The RATHMINES INITIATIVE

Re; Application WEB2816/25 - Observation

On behalf of The Rathmines Initiative (TRI), I submit the following observation regarding Application WEB2816/25, relating to the proposed HSE Rathmines Primary Care Centre (PCC) to be located at the Gulistan Recycling Centre:

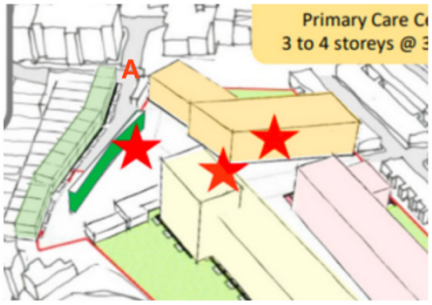
- Purchase of the Peter Marks premises, which occupies the other side of the lane alongside the Town Hall building, connecting the main Rathmines Road to the site. This would provide for a viable fully accessible pedestrian route connecting the site to public transport in the long term, and for construction traffic during the construction stage.

- Alternatively or in addition, the temporary acquisition, for the construction stage, of a right-of-way across the Swan Centre rear service yard, which connects the public road at Castlewood Terrace (where it is still wide and carries heavy delivery traffic) to the site.

Diagram Comparing Public Open Space in DCC Masterplan to HSE PCC Application

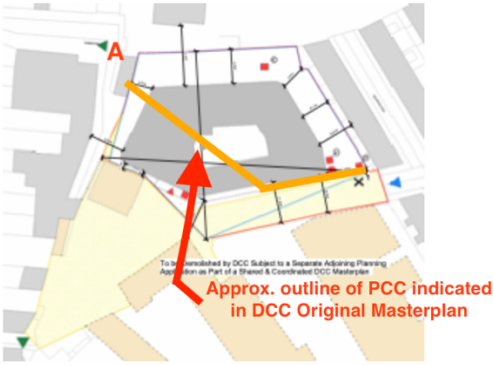
- TRI suggest that the expense of these measures could be funded by adjusting the development charge accordingly. The Rathmines Initiative is also concerned that the HSE scheme indicates that the public open space / civic realm of the overall Gulistan development (the PCC plus the anticipated DCC / Clúid residential component) would be only approx. 50% of the extent suggested in the original City Council Masterplan for the development. (See comparator diagram below.) It is clear that the DCC masterplan indicated that the public open space would extend as far as the Parker Hill building at the North-West corner of the site, indicated "A" on the sketch. Since the PCC development will determine the layout of the site for centuries to come, TRI believes that an unrepeatable opportunity exists now to secure an enhanced public asset in the form of an

increased civic realm public space for the community of Rathmines which is signally lacking in such facilities. TRI asks that the planning authority facilitate this enhanced public asset by conditioning any permission on reducing accordingly the footprint of the PCC.
